NCWG Letter 10/2024

New Symbols for S-101 Anchorage Areas (Action NCWG10/14)

New Symbols for S-101 Anchorage Areas [Revision 2](#)

Submitted by:	United States (NOAA)
Executive Summary:	Symbols for the portrayal of several S-101 Anchorage Area categories are proposed for consideration by NCWG to subsequently recommend for adoption by the S-101 Project Team.
Related Documents:	<ul style="list-style-type: none"> • NCWG9-05-14.A, “S-101 Portrayal Proposals,” submitted by the Australian Hydrographic Office, S-101 Portrayal Sub-Working Group Lead • NCWG10-06-6.A, “Action 8 to 11 – NCWG9,” submitted by Service Hydrographique et Océanographique de la Marine • NCWG9 (Nov 2023 – Taunton) Meeting Minutes and Actions • S-4, Sections B-431.1, B-431.3, and B-431.7 • S-65, Annex B, S-57 ENC to S-101 Conversion Guidance, Edition 1.2.0 – April 2024 • S-101 ENC Product Specification, Annex A, Data Classification and Encoding Guide (DCEG), Edition 1.2.0 – November 2023 • IHO Geospatial Information Registry, IHO Hydro Portrayal Register
Related Projects:	Development of S-101 ENC portrayal in ECDIS S-4 Document maintenance

Figure 4. S-4, Section B-431.3 showing recommended changes

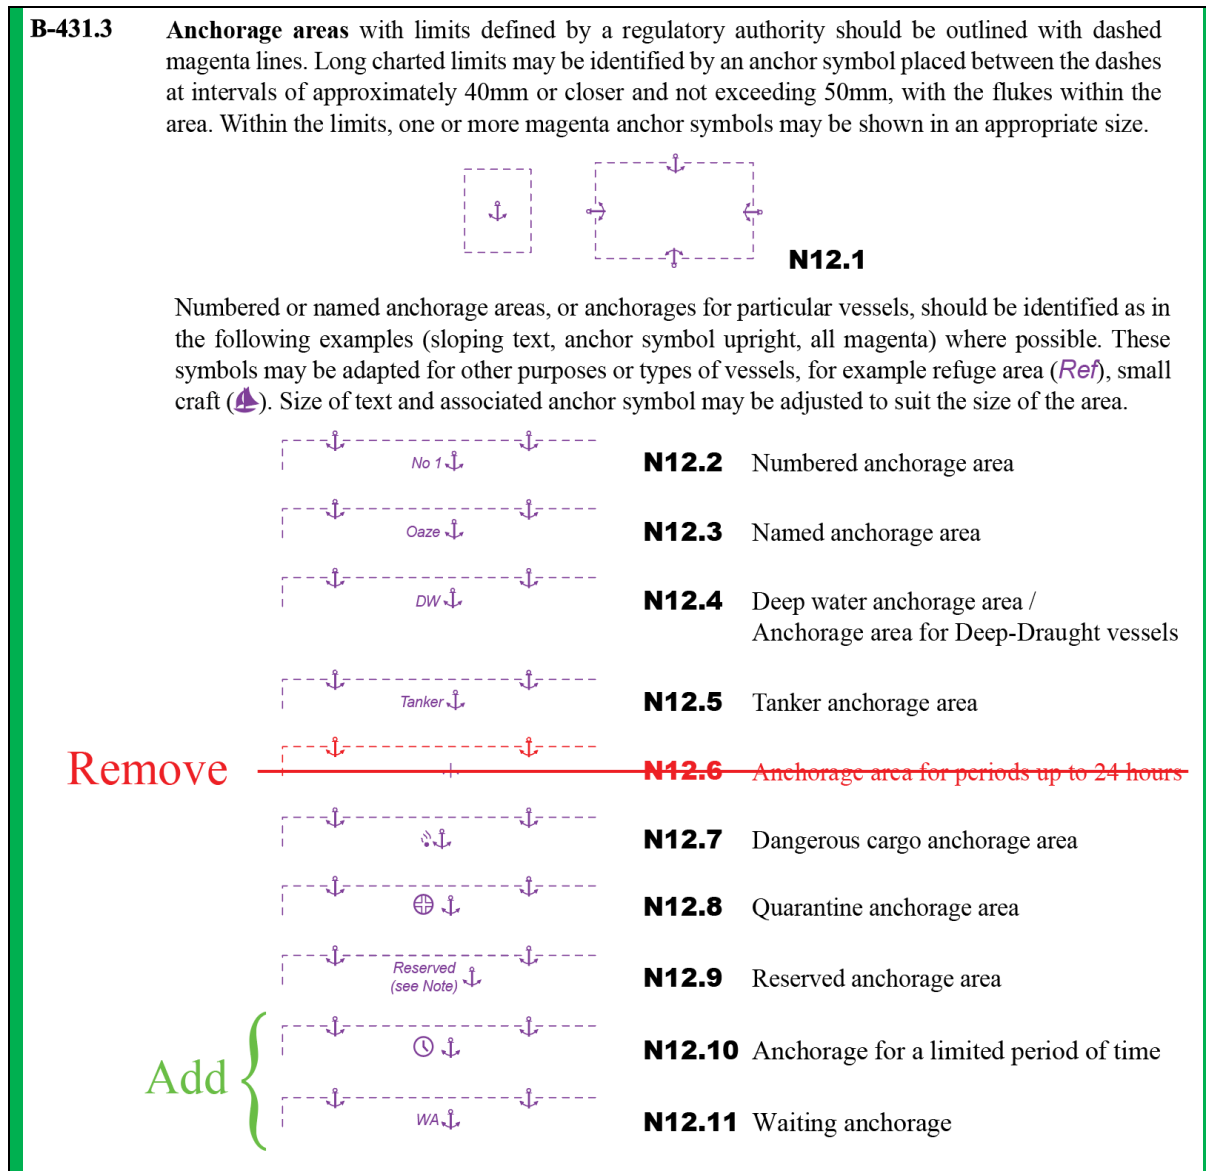
This proposal impacts the language and the figures found within S-4, Section B-431.3 captured in Figure 4.
